**Constellation  
Energy Group**  
Nine Mile Point  
Nuclear Station

August 15, 2003  
NMP2L 2096

**SUBJECT:           Nine Mile Point Unit 2  
                          Docket No. 50-410**

**License Amendment Request Pursuant to 10 CFR 50.90: Revision of  
Reactor Pressure Vessel Pressure-Temperature Limits**

Figure 3.4.11-4 (Page 1 of 1)  
Nuclear Heatup Curve

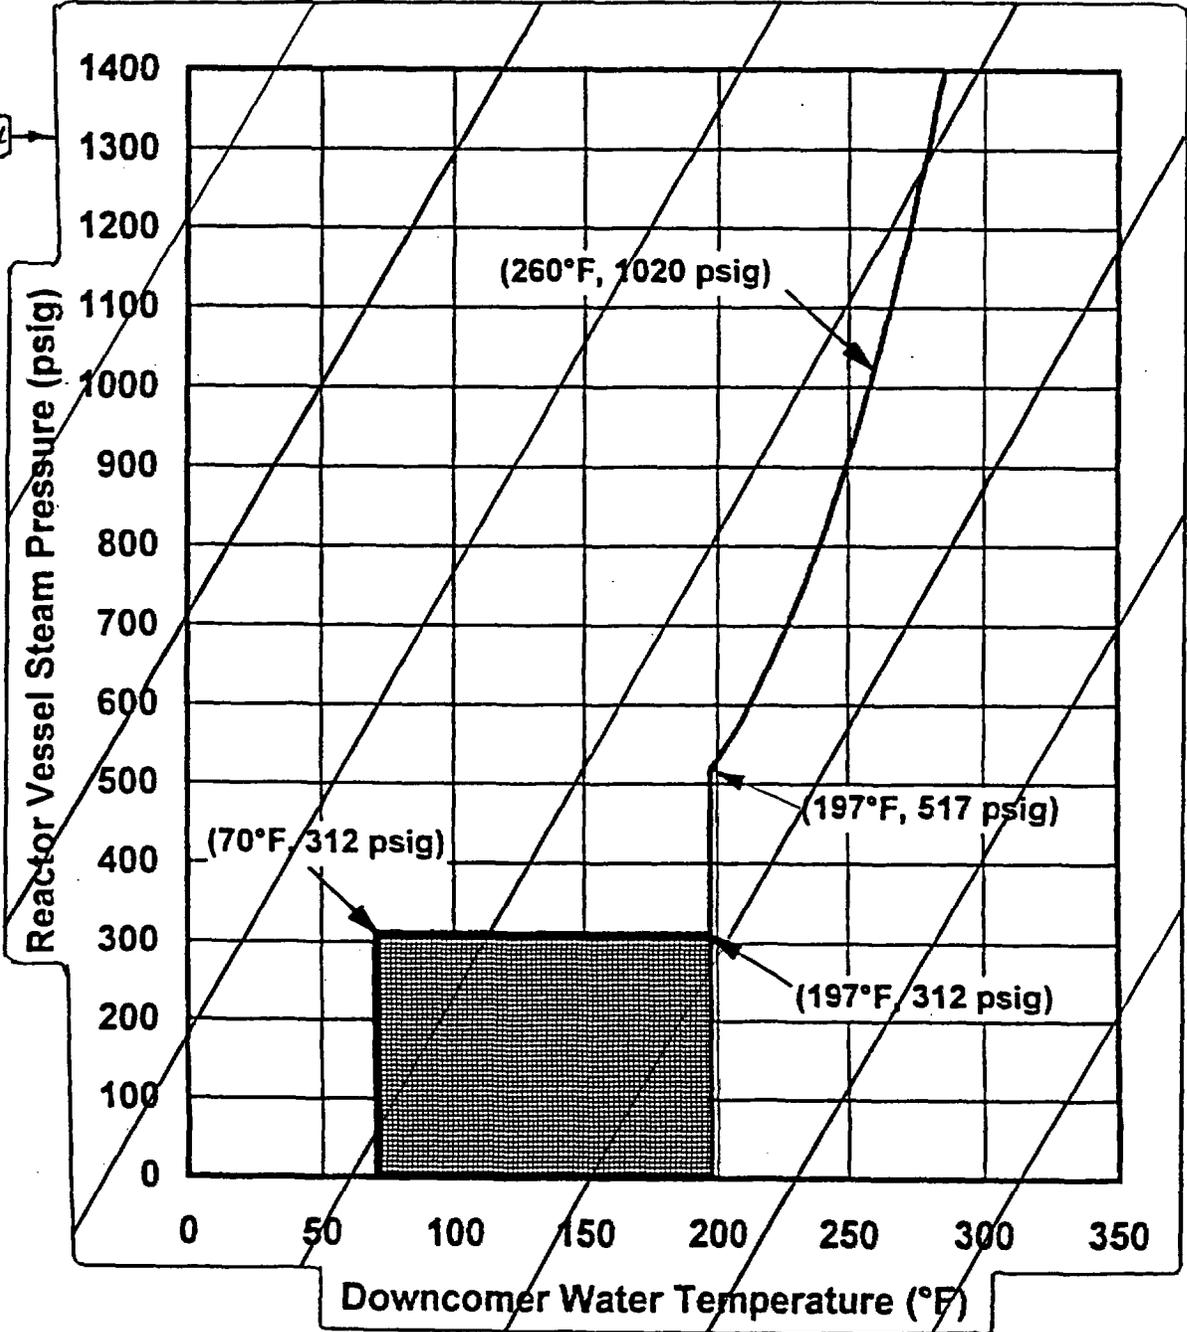
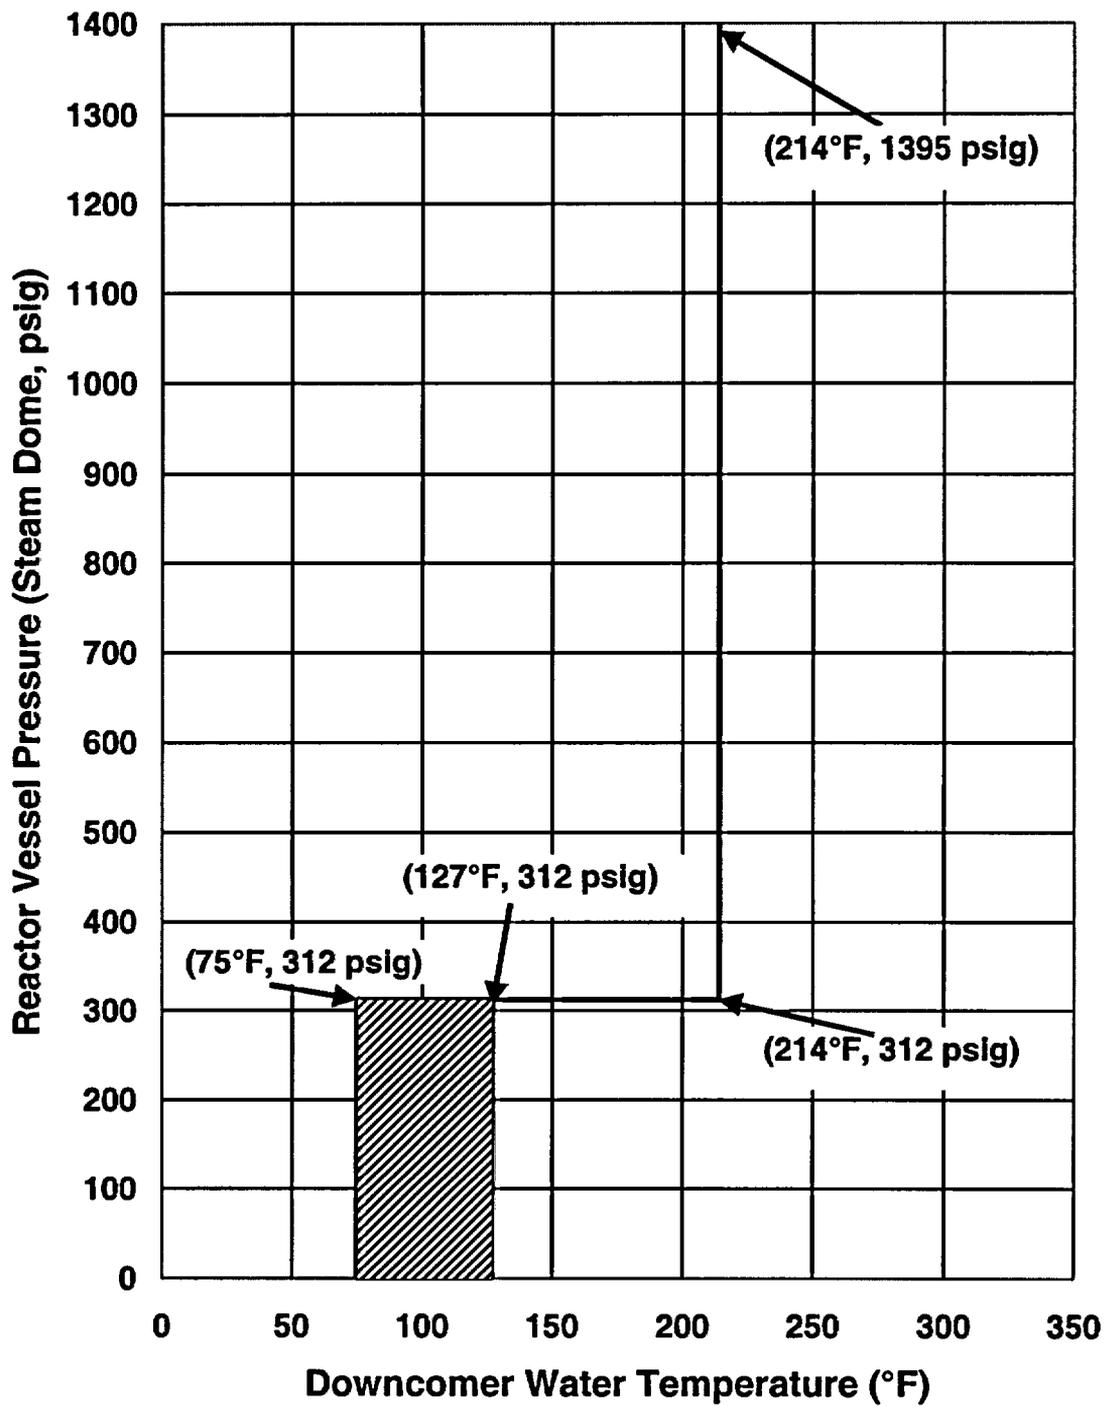
TS Figures 3.4.11-1 through 3.4.11-5 are being replaced with new figures to provide revised (recalculated) RCS P-T limit curves. The revised P-T limit curves will be valid for up to 22 EFPY and are applicable to system leakage and hydrostatic testing and RPV heatup and cooldown during reactor core non-criticality (non-nuclear) and criticality (nuclear) conditions.

INSERT  
FIGURE 3.4.11-4

Figure 3.4.11-5 (Page 1 of 1)  
Nuclear Cooldown Curve

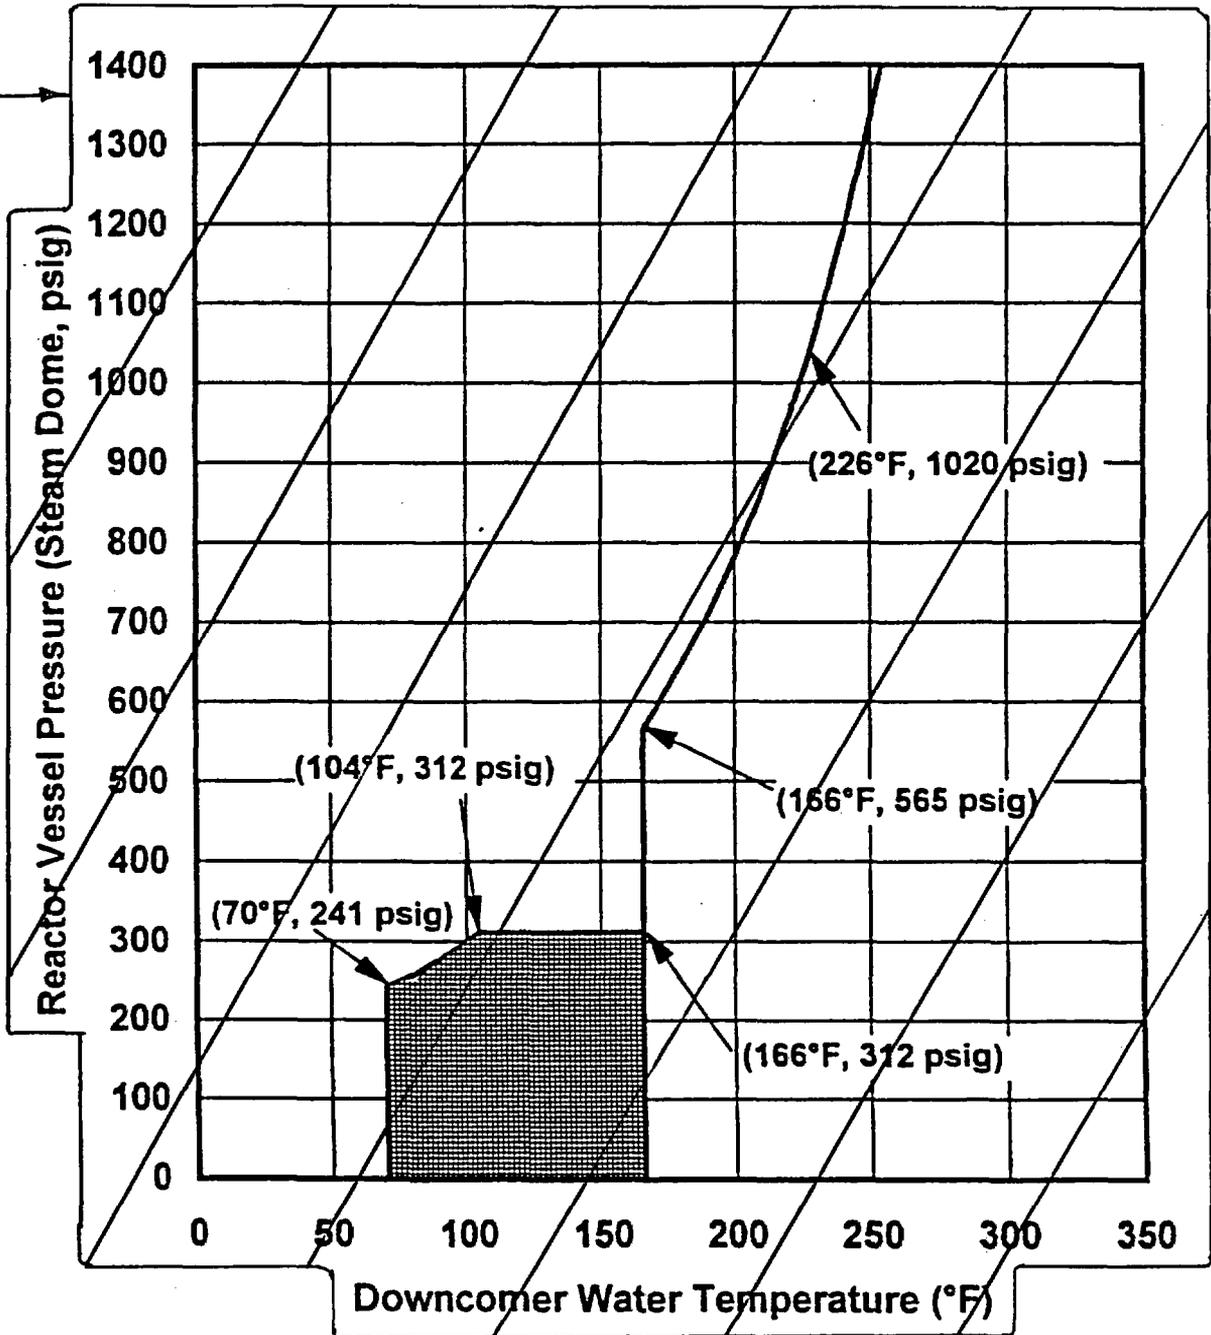
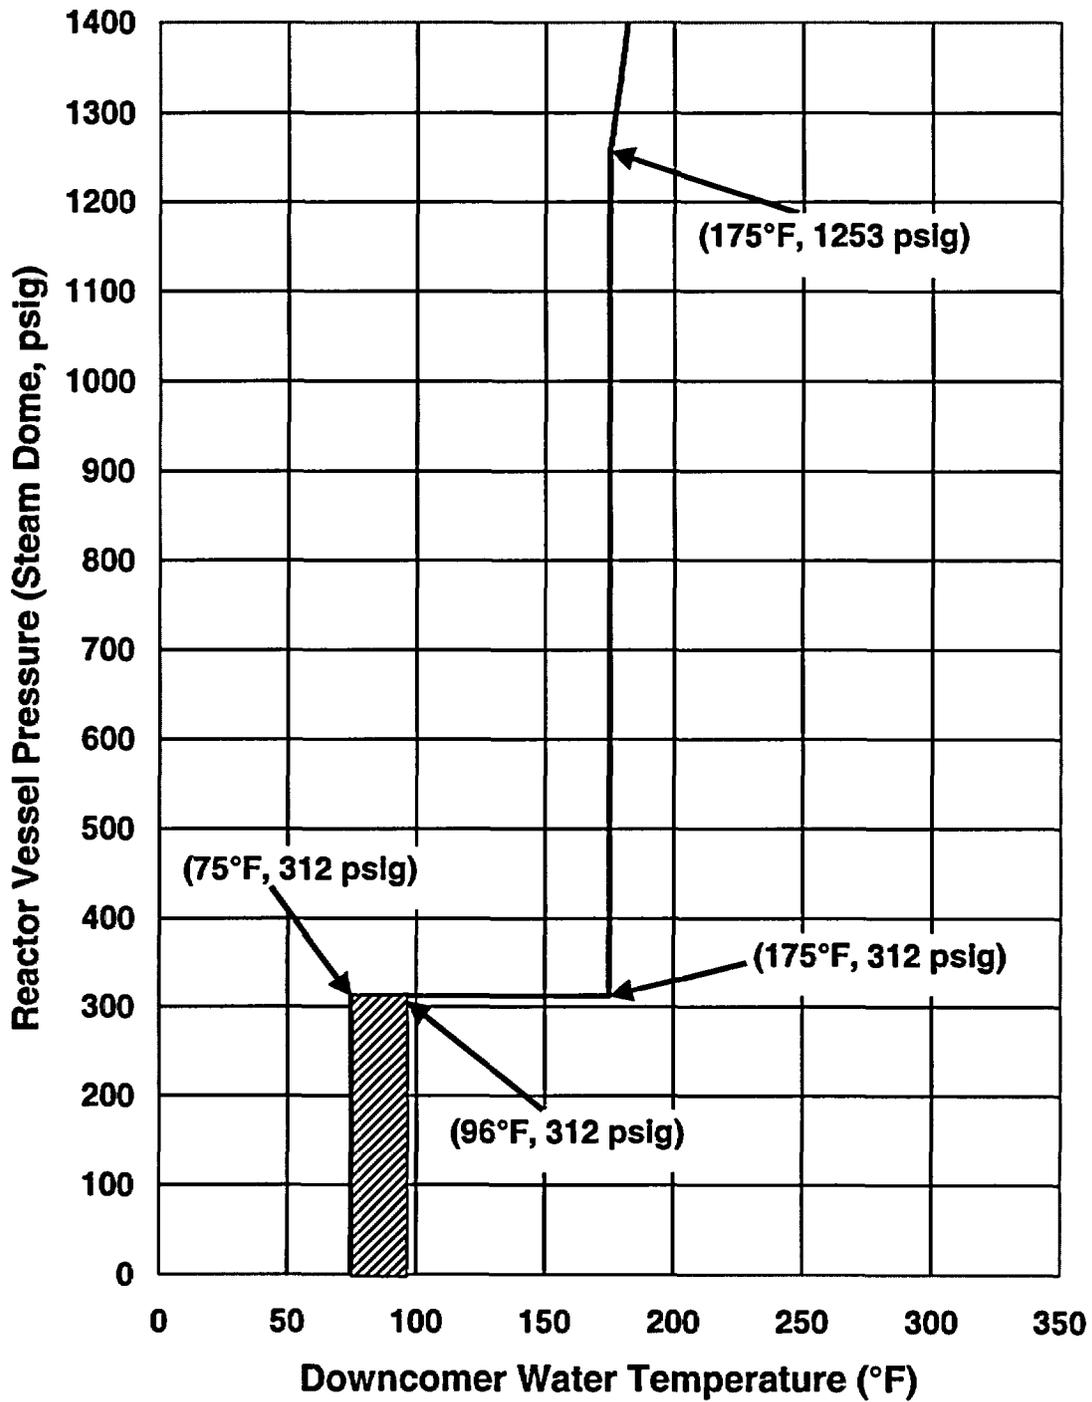
INSERT  
FIGURE 3.4.11-5
